DESIGN	RF	DART AEROSPACE USA, INC. KENT, WA	
DRAWN	DL		
CHECKED		DRAWING NO. D3901	REV. PD4 SHEET 4 OF 4
MFG. APPR.		TITLE BAR	SCALE NTS
APPROVED			
DE APPR.			
DATE	12.08.21	COPYRIGHT © 2009 BY DART AEROSPACE USA, INC. THIS DOCUMENT IS PRIVATE AND CONFIDENTIAL AND IS SUPPLIED ON THE EXPRESS CONDITION THAT IT IS NOT TO BE USED FOR ANY PURPOSE OR COPIED OR COMMUNICATED TO ANY OTHER PERSON WITHOUT WRITTEN PERMISSION FROM DART AEROSPACE USA, INC.

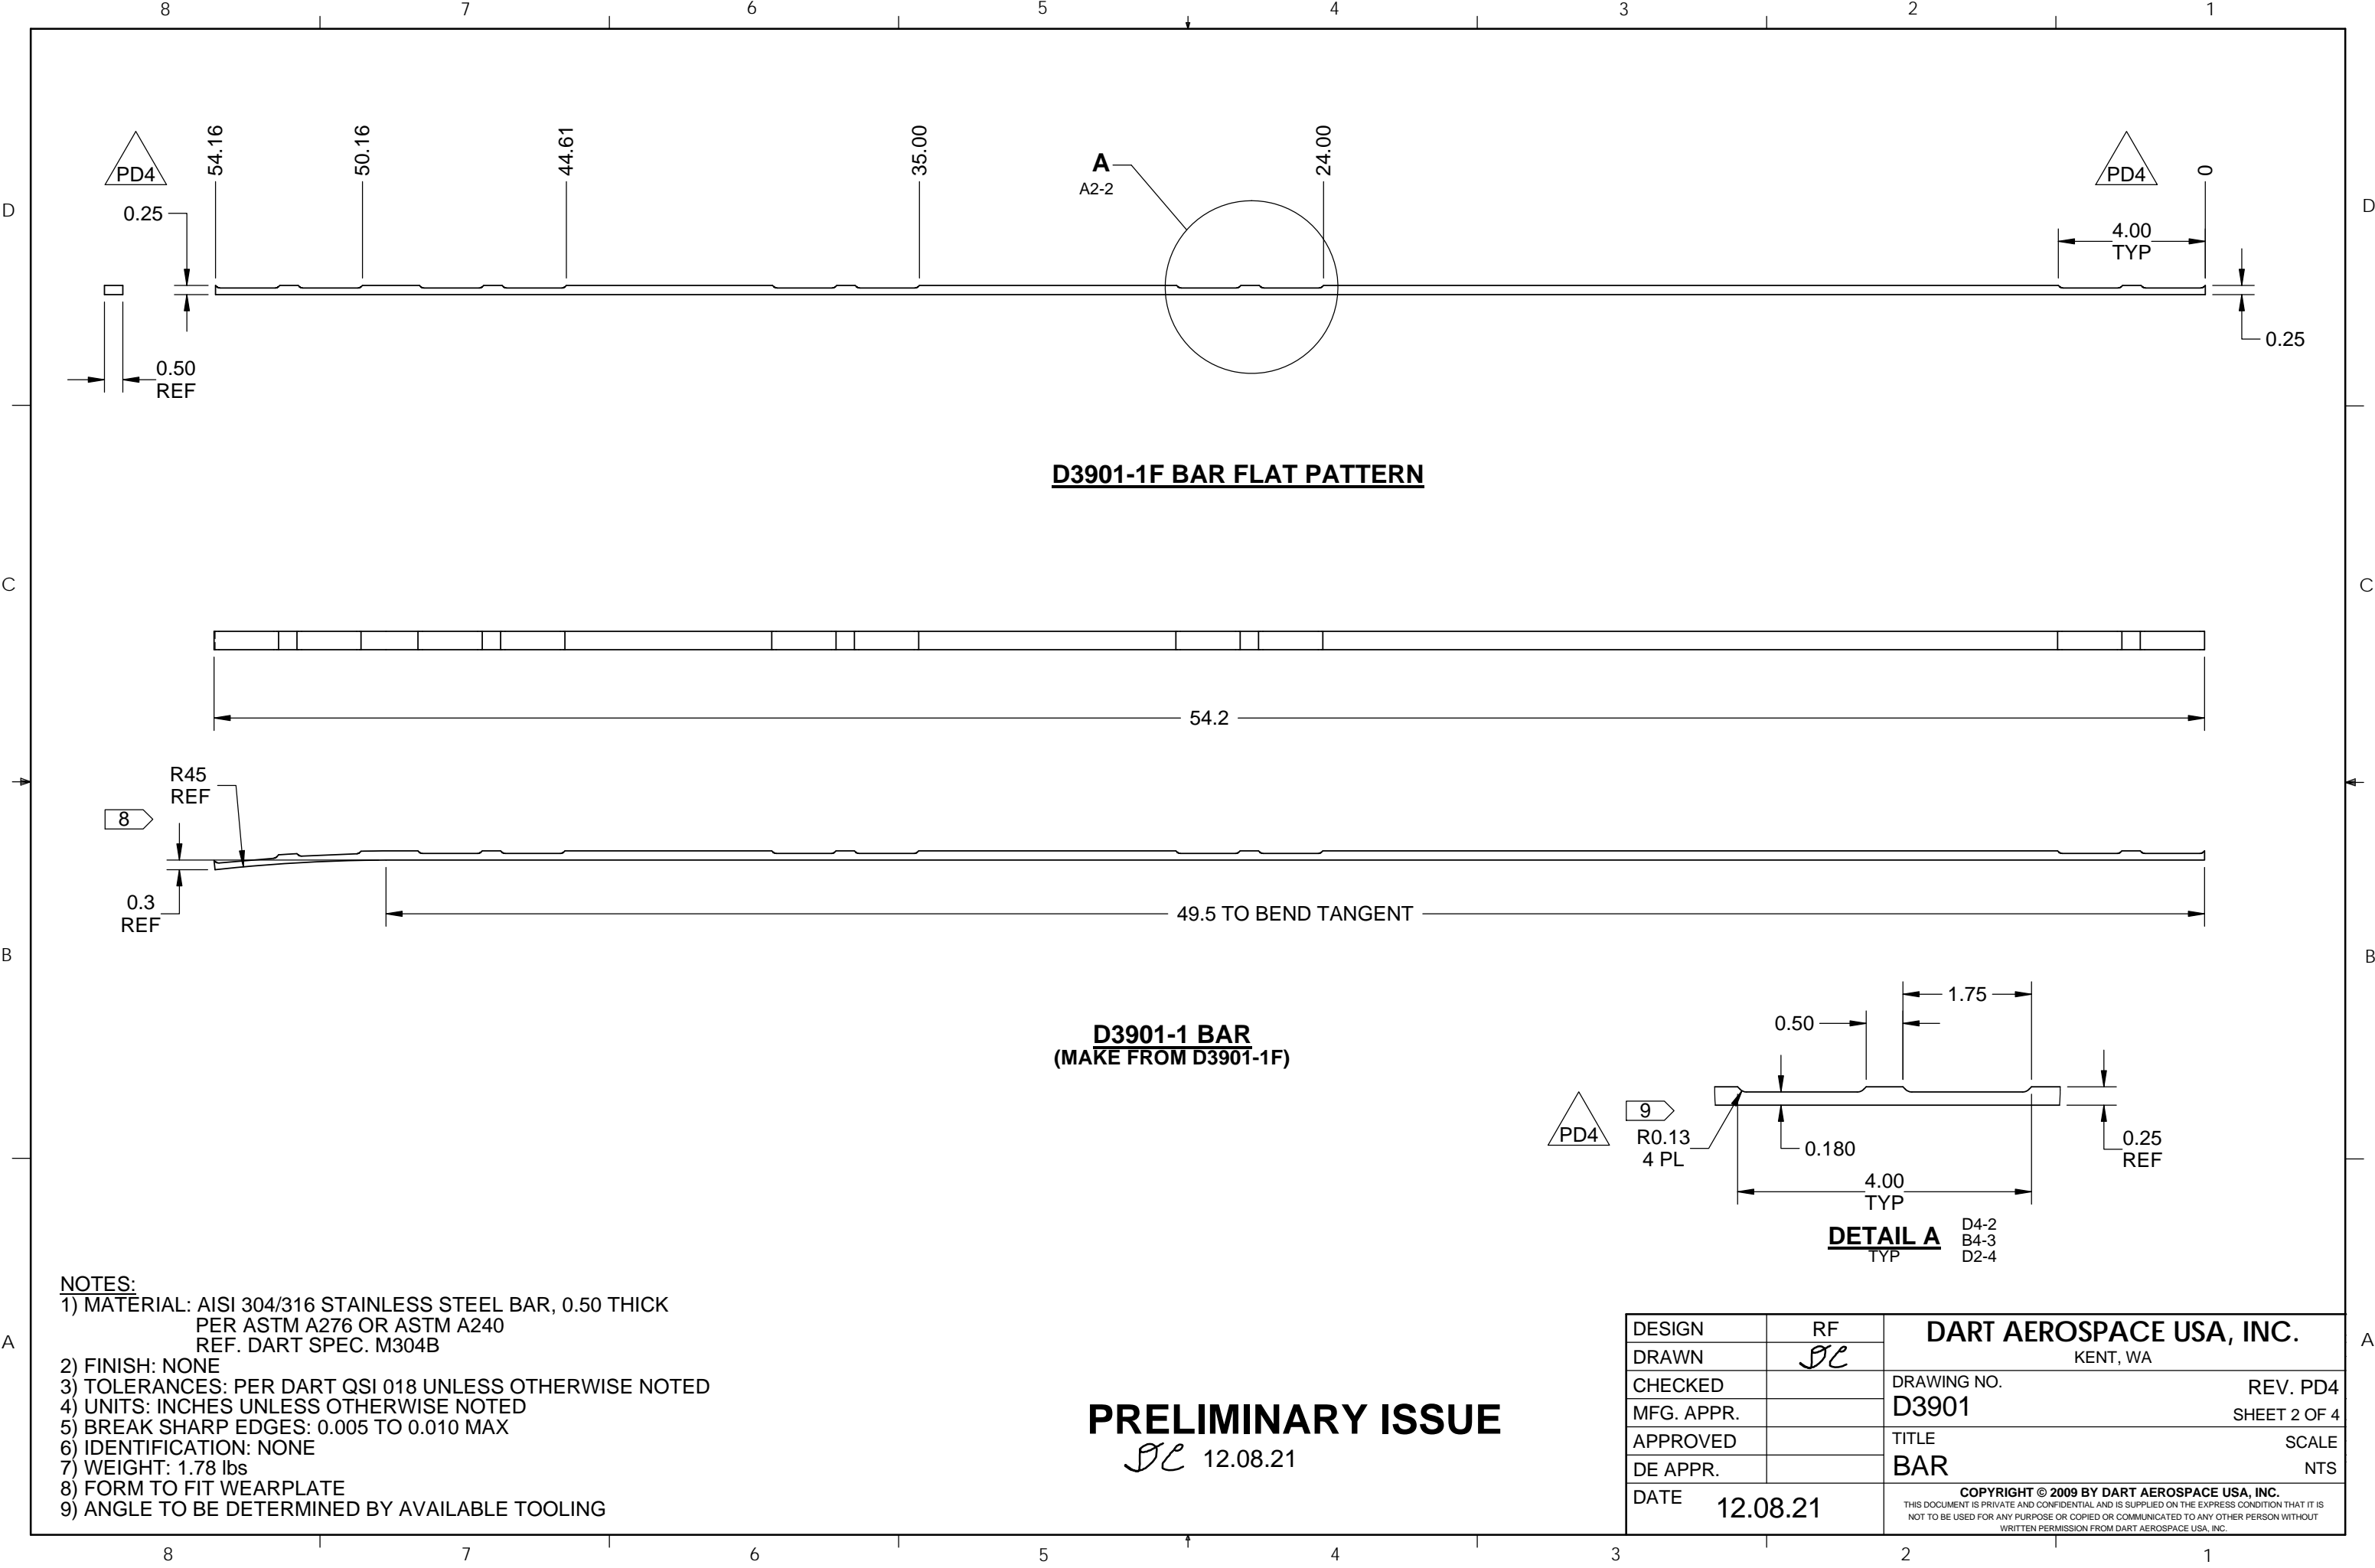
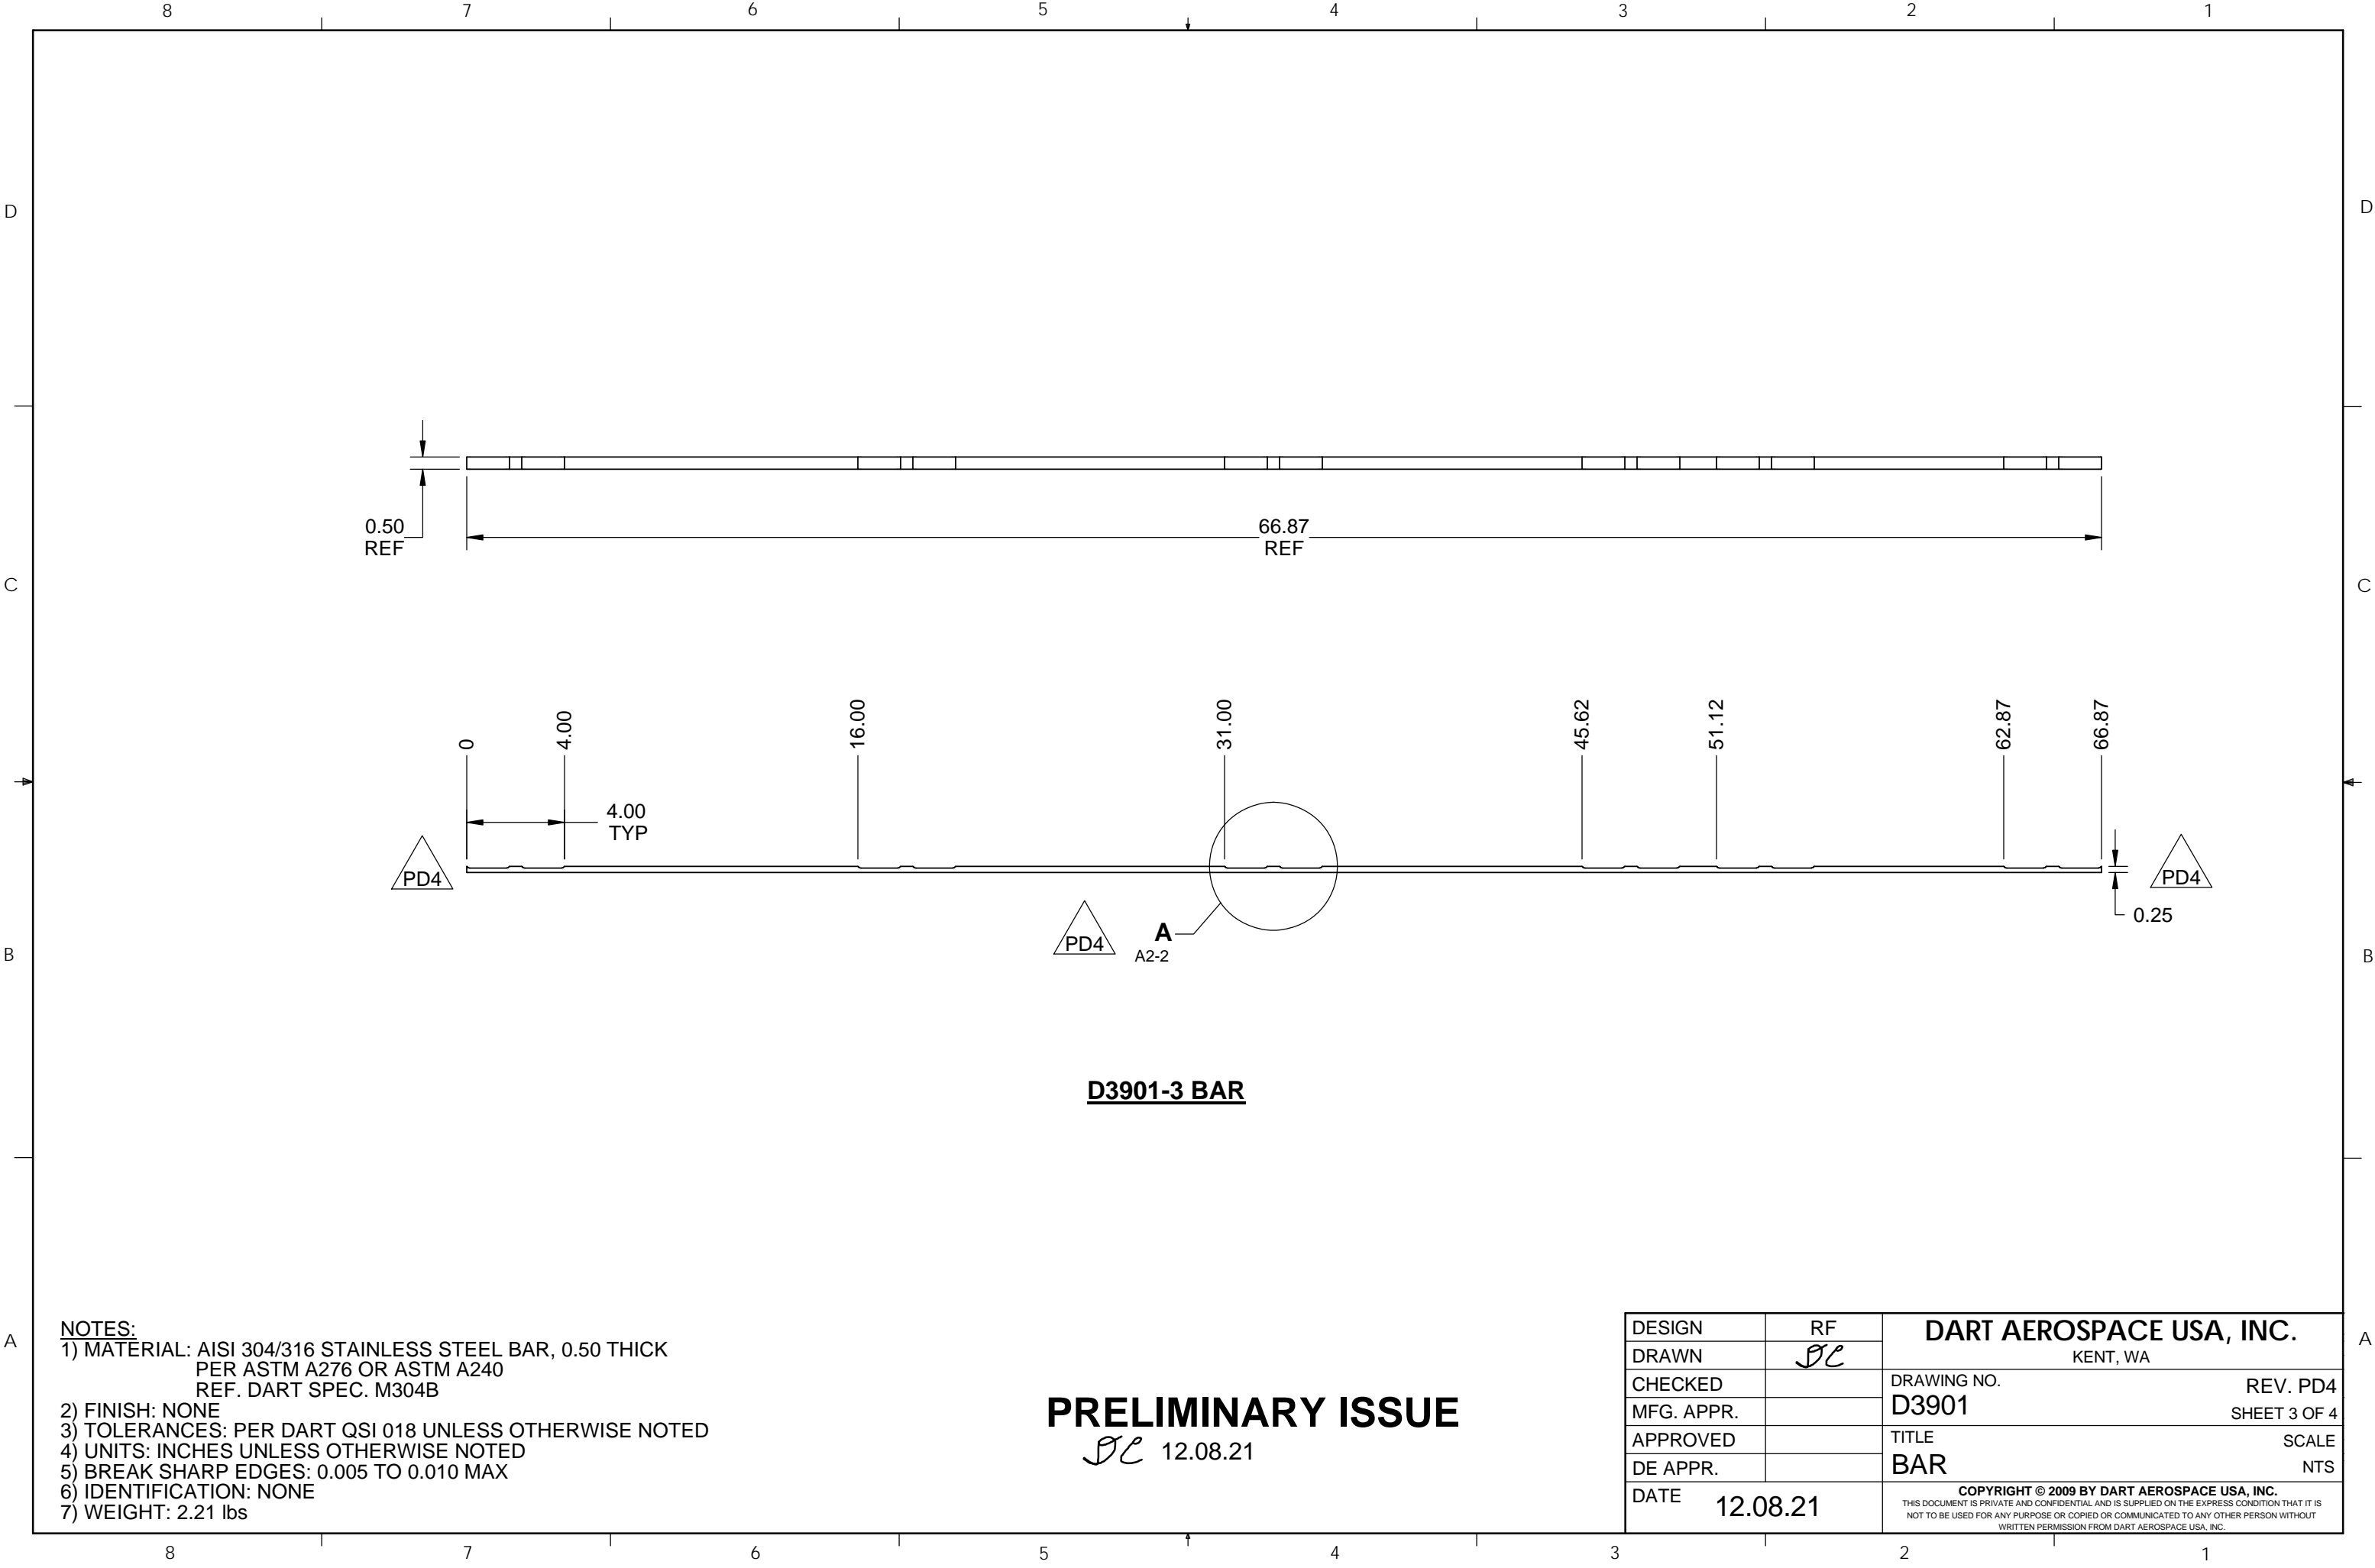
PD4	CHANGE LOCATION OF END POCKETS ON -1/-3/-5 (ZN D1-2, D8-2, B7-3, B2-3, D1-4, D8-4). SPLIT POCKETS INTO TWO SEPARATE POCKETS (ZN A2-2). ADD POCKET TO -1 (ZN D6-2).	DC	12.08.21
C	0.25 WAS 0.20 AND 0.130 WAS 0.080 (ZN B2-2, B1-2, B1-3, D8-4); ADD MISSING DIMENSIONS (ZN C5-3); ADD D3901-1F/-5F FLAT PATTERN	RF	12.01.24
B	REMOVE \varnothing 0.188 HOLES FROM D3901-1/-3/-5; 62.12 WAS 62.61 (ZN C4-3)	RF	09.06.30
A	NEW ISSUE	RF	09.03.30
REV.	DESCRIPTION	BY	DATE
DESIGN	RF	DART AEROSPACE USA, INC. KENT, WA	
DRAWN	JC		
CHECKED		DRAWING NO. REV. PD4	
MFG. APPR.		D3901 SHEET 1 OF 4	
APPROVED		TITLE SCALE	
DE APPR.		BAR NTS	
DATE	12.08.21	COPYRIGHT © 2009 BY DART AEROSPACE USA, INC. <small>THIS DOCUMENT IS PRIVATE AND CONFIDENTIAL AND IS SUPPLIED ON THE EXPRESS CONDITION THAT IT IS NOT TO BE USED FOR ANY PURPOSE OR COPIED OR COMMUNICATED TO ANY OTHER PERSON WITHOUT WRITTEN PERMISSION FROM DART AEROSPACE USA, INC.</small>
